Public Hearing

CASE SUMMARY SHEET

CASE NUMBER: V26-07-23
DATE RECEIVED: June 24, 2026
DATE OF MEETING: July 14, 2026 and July 28, 2026

REQUEST: V26-07-23 – Joshua S. Brandner, requests a variance to CLURO Section 5.2.3.2. Drainage Overlay District and Fill Sub-Area A, Old Town of Mandeville, Square 10 Lot 2A, B-3 Old Mandeville Business District, 214 Girod

AS-BUILT DRAINAGE OF
A PORTION OF GROUND SITUATED IN SQUARE 10
TOWN OF MANDEVILLE * CITY OF MANDEVILLE
ST. TAMMANY PARISH, LOUISIANA

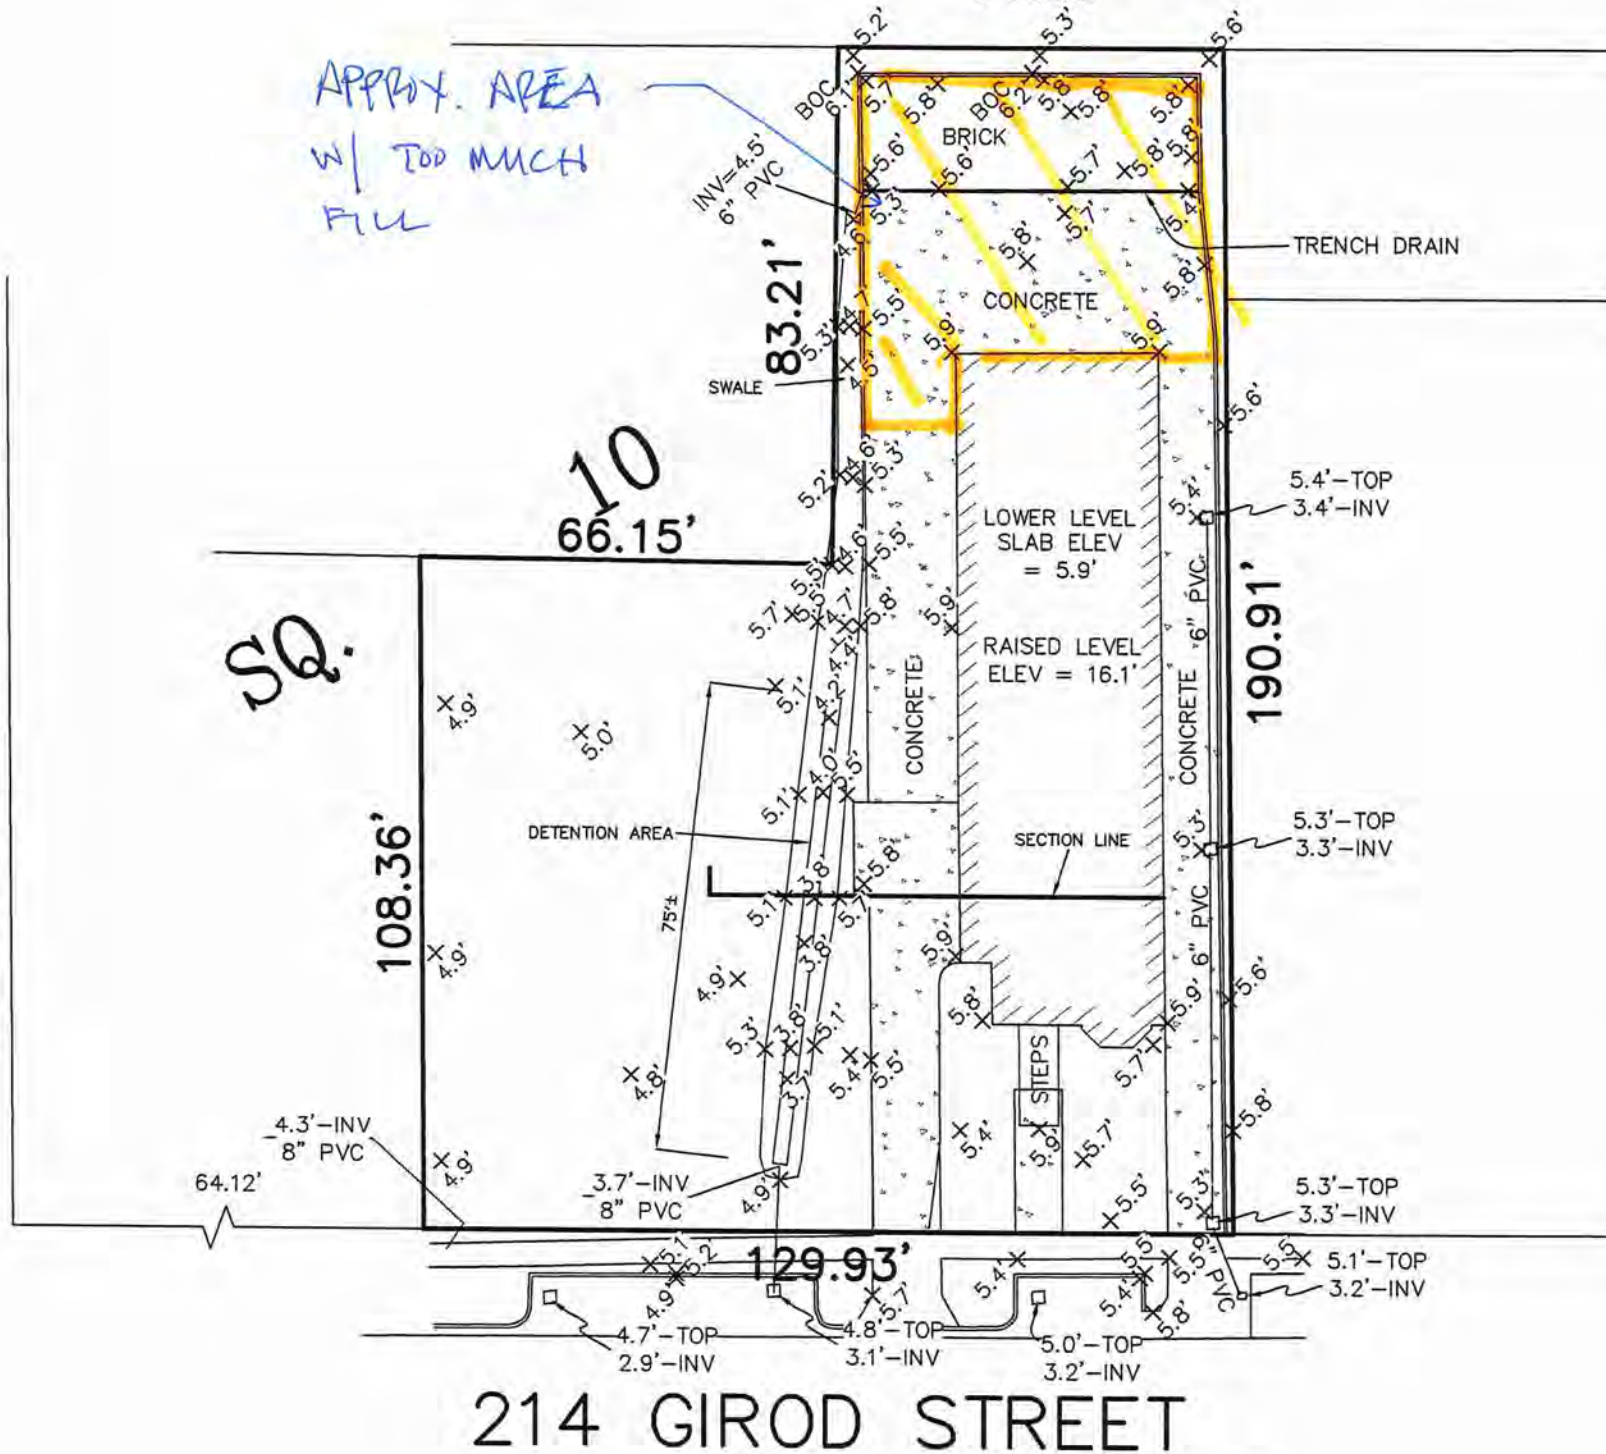
The applicant received the final drainage inspection on June 1st which failed as the rear concrete driveway exceeds the fill requirements in the CLURO. The application states that this is due to the parking/base slab under the building being installed higher than originally intended. A variance is being requested to allow the pavement to remain in place as constructed due to the transition to the slab under the building that cannot be corrected and to ensure proper access to the parking under the building as well as ADA compliance. The application states that the site does not drain on any adjacent properties and is currently functioning as indented with no adverse impacts to any adjacent property.

The City Engineer reviewed the submitted documents and had the following comments: *“This project is in both the DO Overlay and Fill area A. It appears they used the grading/drainage plan in the original plan set, that was not approved, was used to set the elevation of the slab under the structure. The first approved drainage/grading plan was prepared by JV Burkes and dated 1/30/2024. See attached. The permittee then requested to change the gravel driveways to be changed to concrete driveways and the gravel parking to permeable pavers, the approved plan was prepared by Kyle & Associates and dated 10/29/2025. Due to not using the plans to set the elevation has resulted in fill up to 18” deep in the rear of the structure”.*

AS-BUILT DRAINAGE OF
A PORTION OF GROUND SITUATED IN SQUARE 10
TOWN OF MANDEVILLE * CITY OF MANDEVILLE
ST. TAMMANY PARISH, LOUISIANA

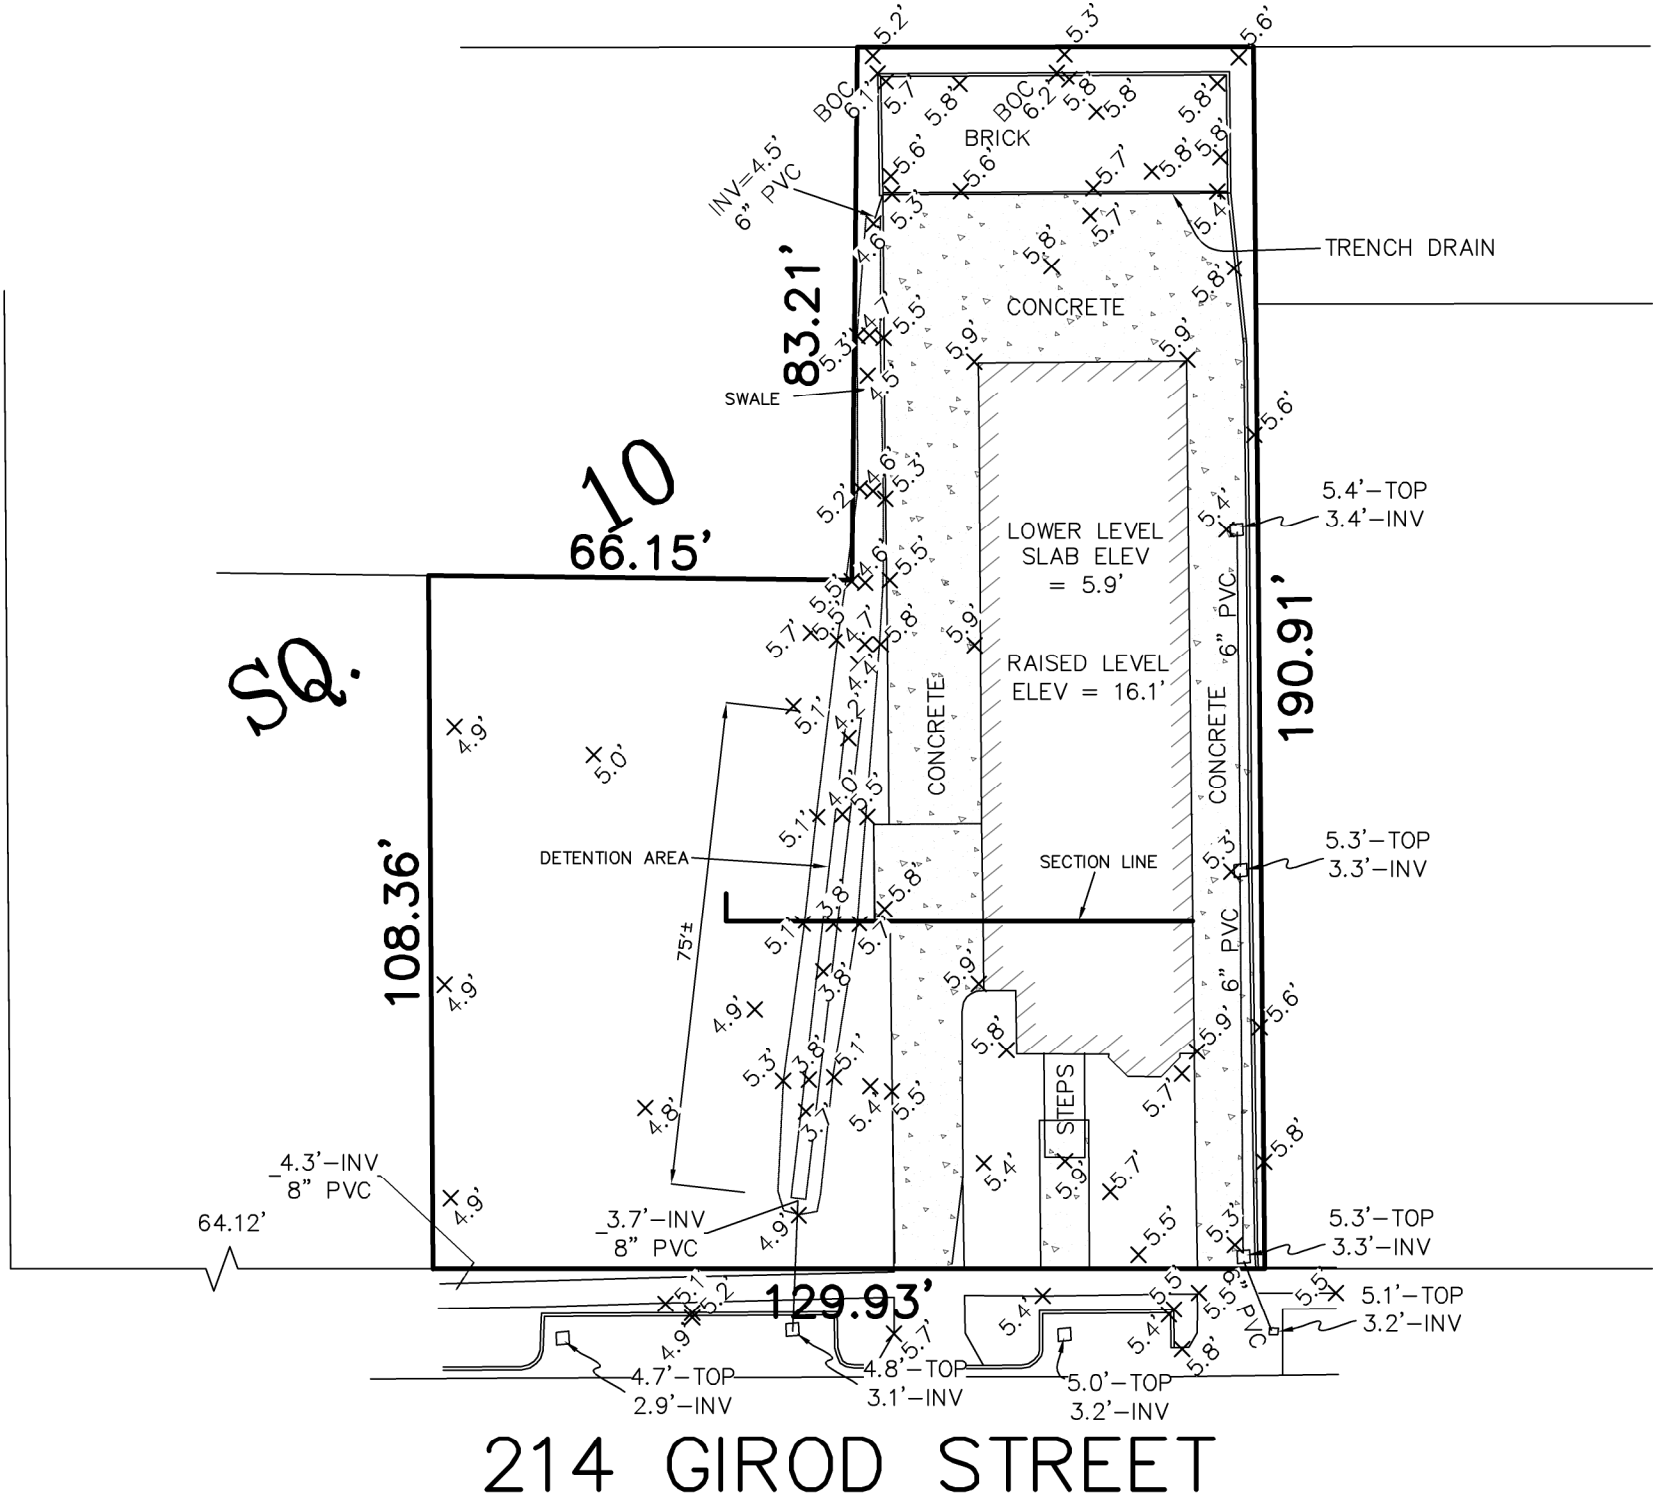
The City Engineer also prepared a figure using the drainage as-built, and noted both the natural grade (NG) of the site prior to construction and the fill above the natural grade in both feet and inches (shown in the parenthesis).

Attached is a figure that I made using the Drainage as-built, I noted the natural grade (NG) of the site prior to construction and the fill above the NG in both feet and (inches). I thought was the easiest way to show.

It appears they used the grading/drainage plan in the original plan set, that was not approved, was used to set the elevation of the slab under the structure. The first approved drainage/grading plan was prepared by JV Burkes and dated 1/30/2024. See attached. The permittee then requested to change the gravel driveways to be changed to concrete driveways and the gravel parking to permeable pavers, the approved plan was prepared by Kyle & Associates and dated 10/29/2025. Due to not using the plans to set the elevation has resulted in fill up to 18" deep in the rear of the structure.

721 Coffee Drainage As Built - referenced in Public Works Email

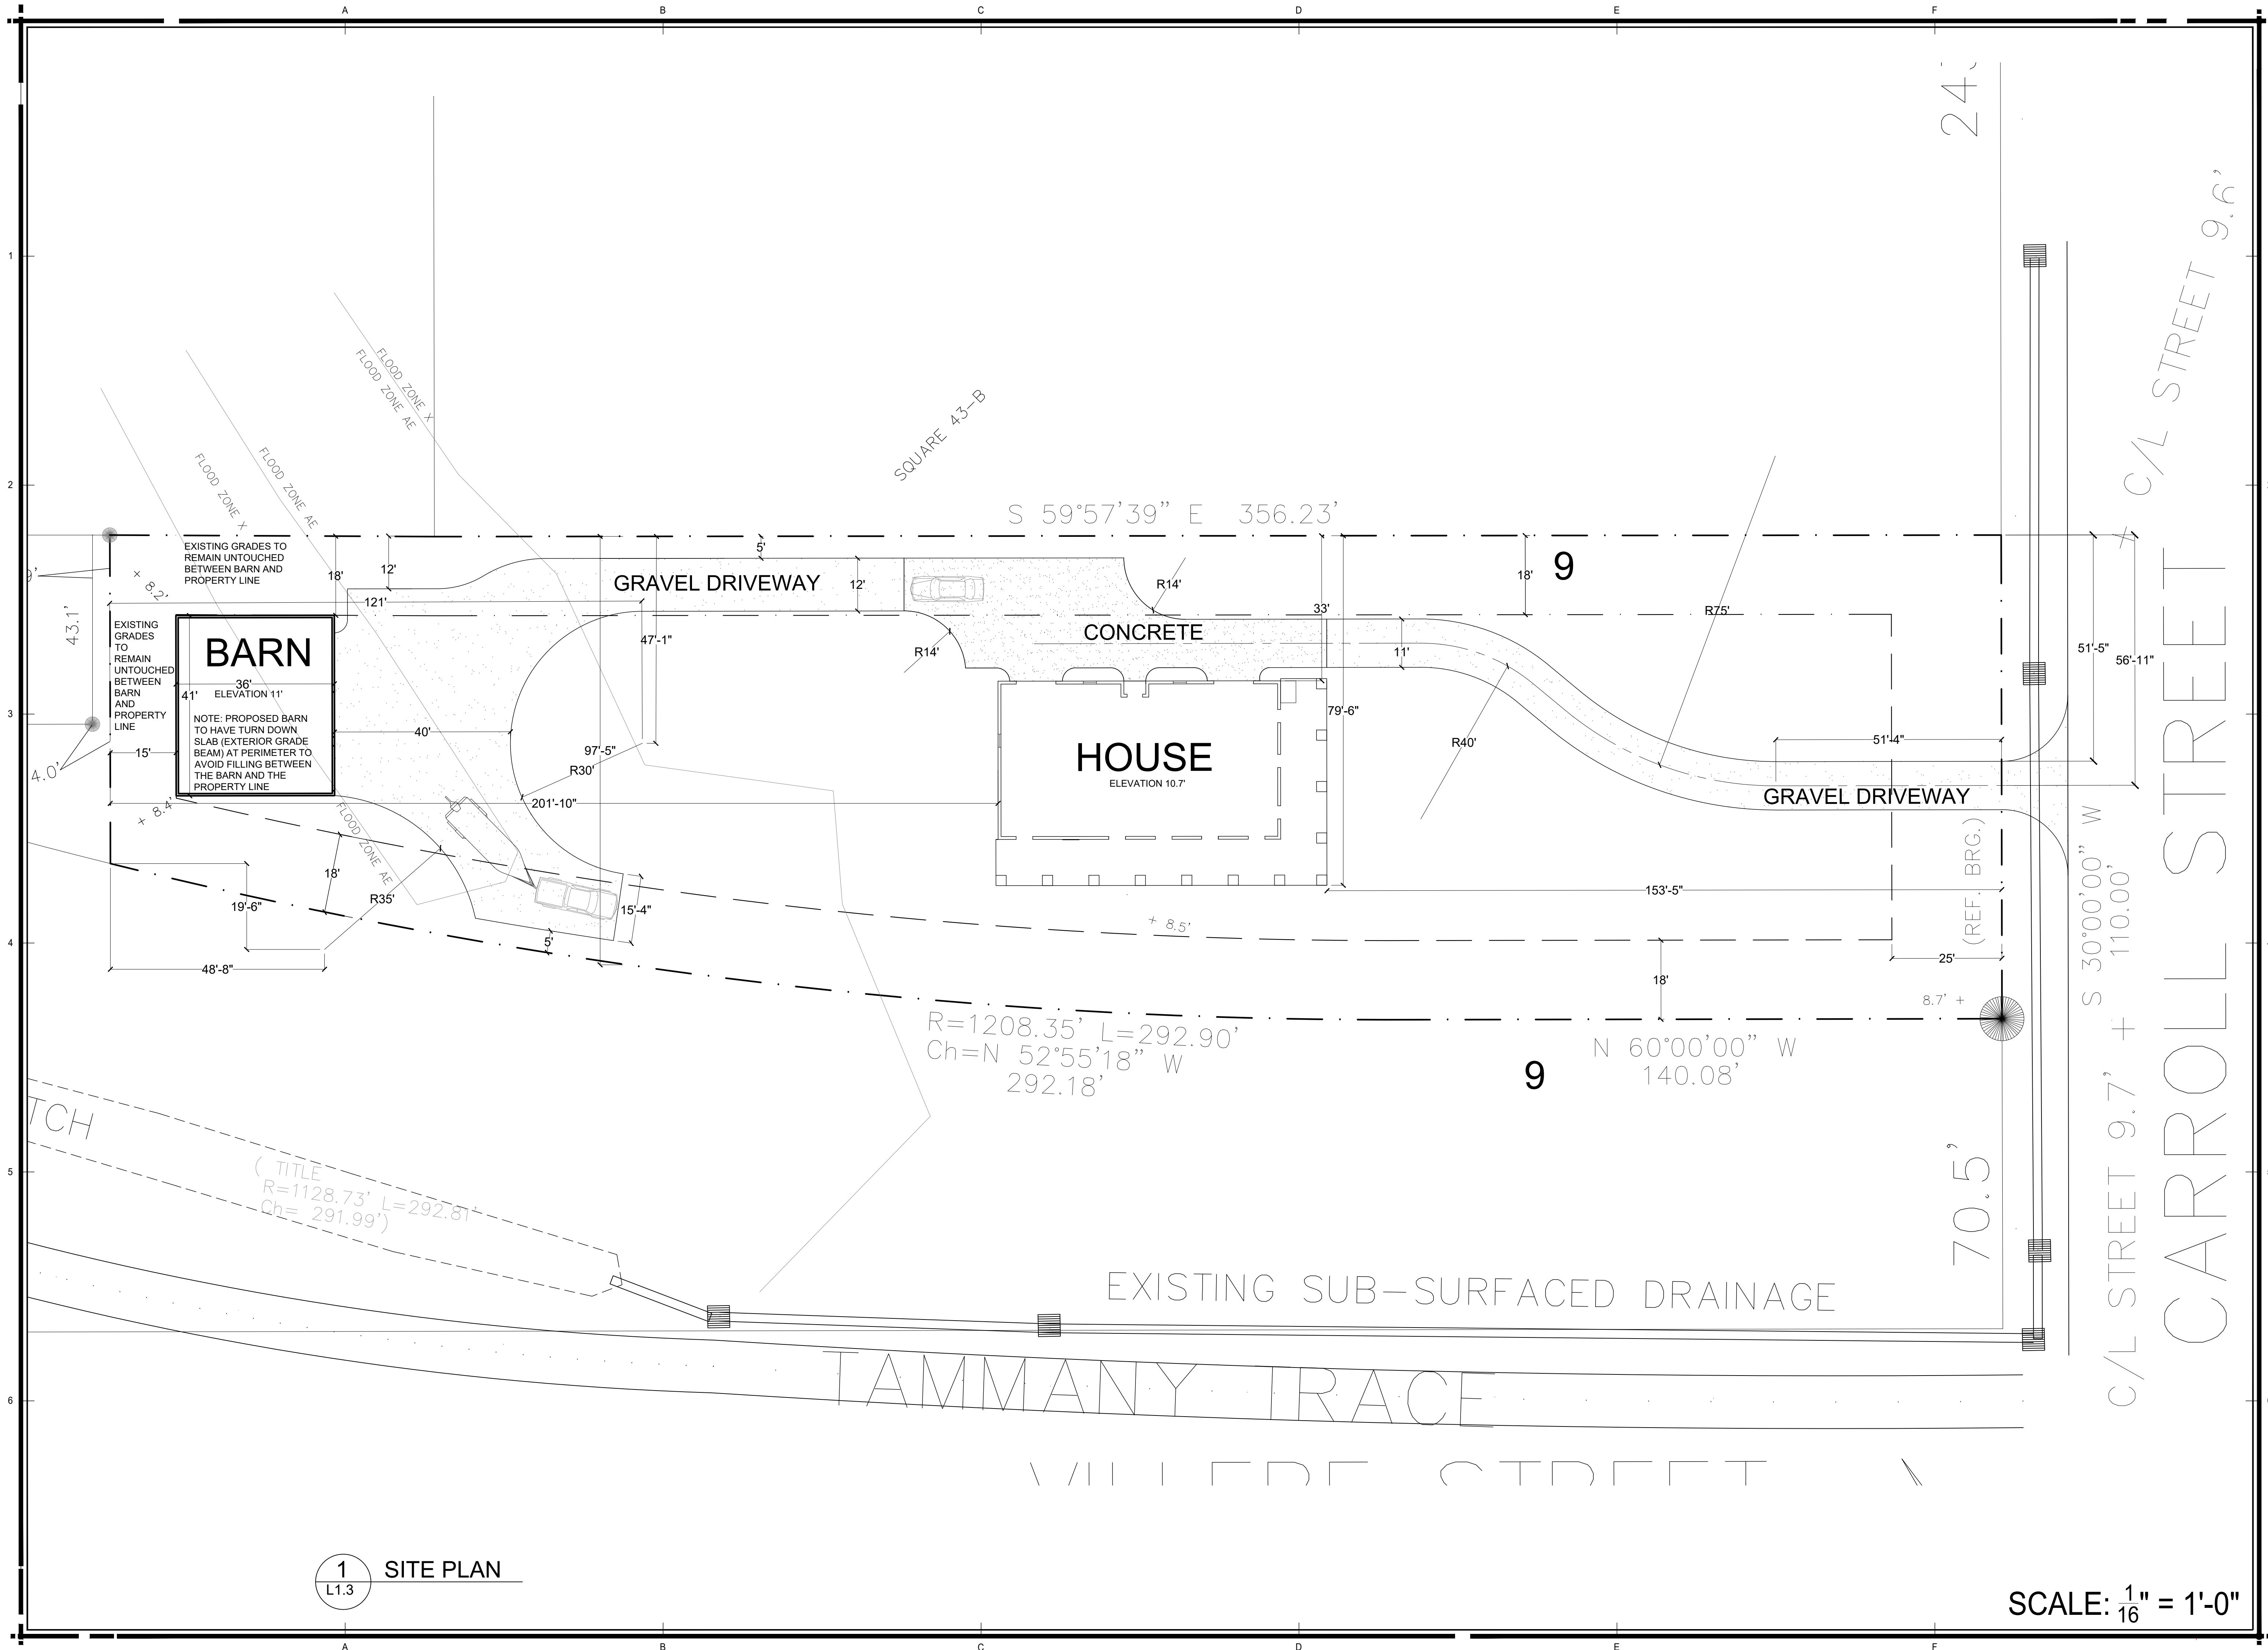
Public Works received the revised Drainage Plan produced by Kelly Mchugh for Fill height variance at 724 Carroll St.

Public Works comments remain unchanged for the request to elevate the top of slab of the proposed garage. The neighbor on Coffee St had concern about the added fill height would cause increased flooding of their garage do to the displacement of volume around Coffee St and the Trace. I have attached the drainage “as built” for 721 Coffee which shows the FFE of the detached garage being 9.20’ which is 1.80’ lower than the proposed structure. Also available in the “as built” are grade shots around the property. The applicant has moved the building within the setbacks. Increasing the setback on the northern property line will allow a greater volume of stormwater to flow around the structure during heavy rain events, but the benefit would be minimal. Kelly Mchugh adjusted the slope of the concrete pad in front of the building to decrease the amount of elevation needed to approach the garage openings. The proposed parking/ approach slab would need to be included in the variance request because the elevation would be 0.70’ above the allowable height for a driveway.
